SUBJECT: Palisades Nuclear Plant Response to Request for Additional Information for the Overall Integrated Plan in Response to the Commission Modifying Licenses with Regard to Requirements for Reliable Spent Fuel Pool Instrumentation

Palisades Nuclear Plant  
Docket No. 50-255  
License No. DPR-20

### Palisades Nuclear Plant Spent Fuel Pool Instrumentation Order Request for Additional Information (RAI) Responses

Figure 1, SFP Elevation View with Levels Indicated

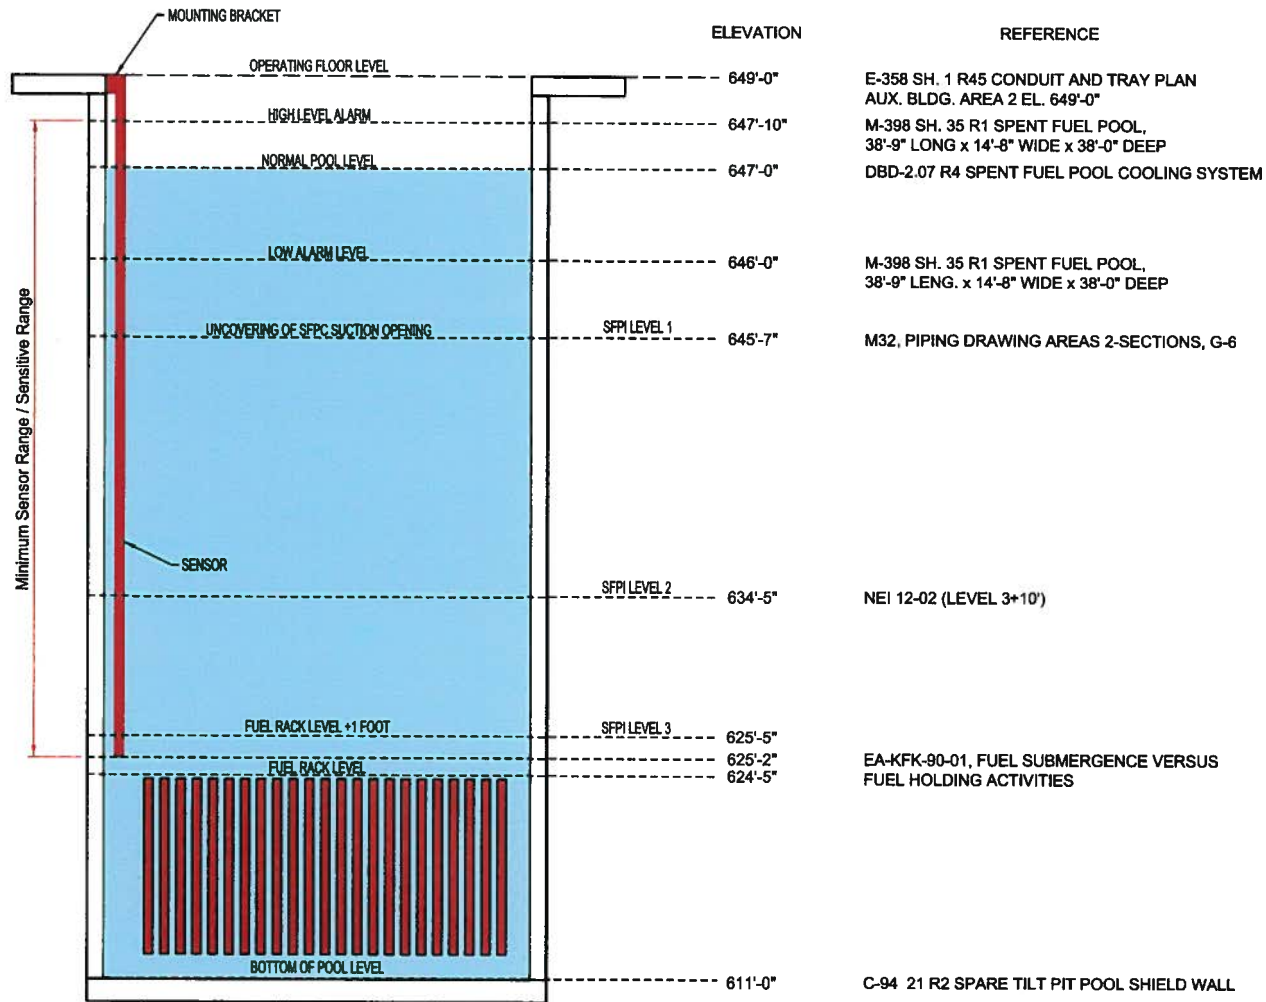
- b) *A clearly labeled sketch depicting the elevation view of the proposed typical mounting arrangement for the portions of instrument channel consisting of permanent measurement channel equipment (e.g., fixed level sensors and/or stilling wells, and mounting brackets). Indicate on this sketch the datum values representing Level 1, Level 2, and Level 3 as well as the top of the fuel racks. Indicate on this sketch the portion of the level sensor measurement range that is sensitive to measurement of the fuel pool level, with respect to the Level 1, Level 2, and Level 3 datum points.*

- a) The water level above the pump necessary to maintain the required net positive suction head (NPSH) for saturated conditions is approximately 605'. This level is well below 645'-7", which is the level at which the cooling pump suction pipe begins to uncover. Therefore, the Level 1 elevation is 645'-7".
- b) The requested information is provided in Figure 1. The figures indicate Levels 1, 2, and 3 as well as the approximate location of the proposed mounting bracket incorporating the Seismic Category I attachment. The sensor is a perforated tubular coaxial waveguide that provides continuous level measurement axially and is sensitive over its entire length. These sketches apply to both the primary and backup channels.

The spent fuel pool (SFP) level lower instrument span or probe bottom extends down to at least three inches below the upper limit of the range of Level 3 to account for channel accuracy or instrument loop uncertainty. Therefore, the SFP level probe bottom/span extends down to at least elevation 625'-2" (see Figure 1). The SFP level upper instrument span, at a minimum, includes the high level alarm. Note that Level 3 is shown in accordance with Nuclear Energy Institute (NEI) 12-02, "Industry Guidance for Compliance with NRC Order EA-12-051, 'To Modify Licenses with Regard to Reliable Spent Fuel Pool Instrumentation,'" Revision 1, guidance relative to the top of the rack; the top of the fuel is not shown.

Figure 2, Plan View of the Spent Fuel Pool Area

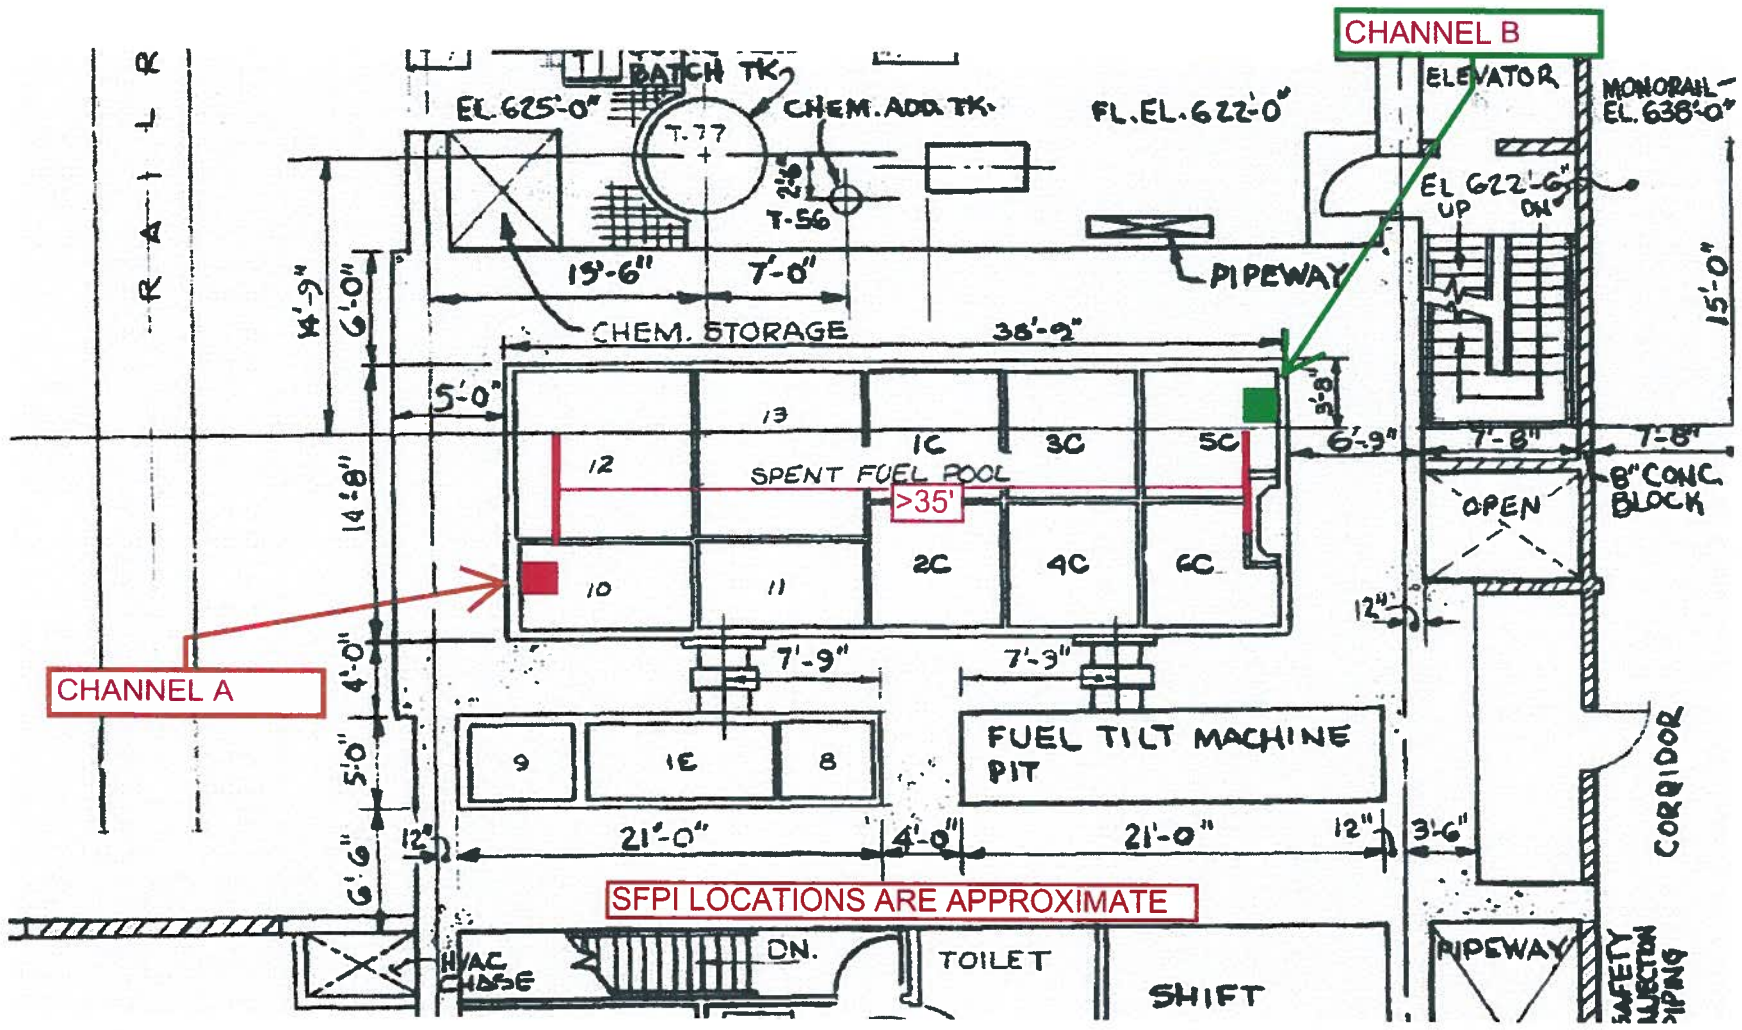
*Please clarify the sketch or marked-up plant drawing of the plan view of the SFP area that you submitted in Attachment 1, to depict the SFP inside dimensions in a more readable manner.*

Figure 2 shows the inside dimensions as requested.

Figure 3, Level Probe

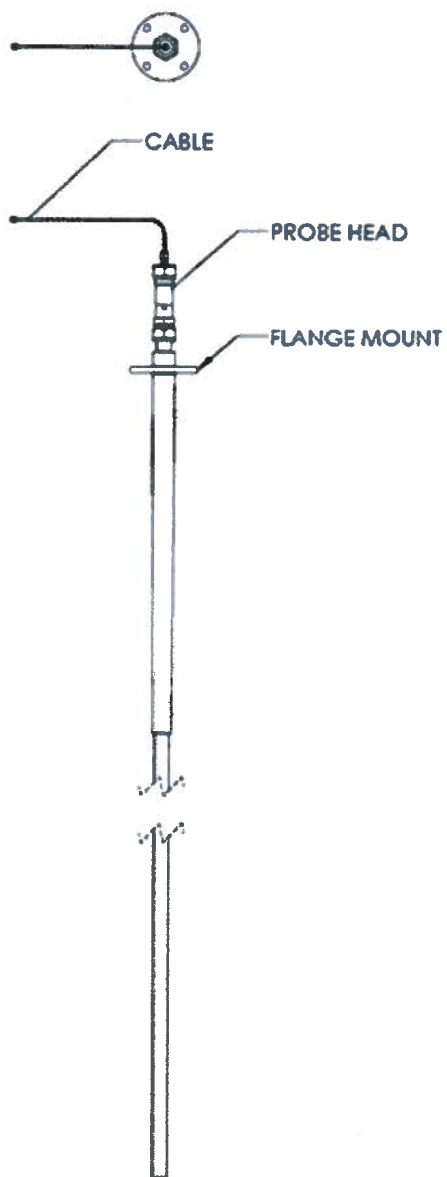
- b) *A description of the manner in which the level sensor (and stilling well, if appropriate) will be attached to the refueling floor and/or other support structures for each planned point of attachment of the probe assembly. Indicate in a schematic the portions of the level sensor that will serve as points of attachment for mechanical/mounting or electrical connections.*

- b) The proximal portion of the level probe is designed to be attached near its upper end (refer to Figure 3) to a Seismic Category I mounting bracket configured to suit the requirements of a particular SFP. The bracket may be bolted and/or welded to the SFP deck and/or SFP liner/wall according to the requirements of the particular installation per Seismic Category I requirements.
- c) See (b) response above.
- d) An evaluation of non-special nuclear material inventory located in the SFP will be performed during the spent fuel pool instrumentation (SFPI) modification process. Non-special nuclear material access to the SFP is governed by EN-RE-220, "PWR Control of Miscellaneous Material in the Spent Fuel Pool." This procedure will be used to prevent any instrument interference from non-special nuclear materials.
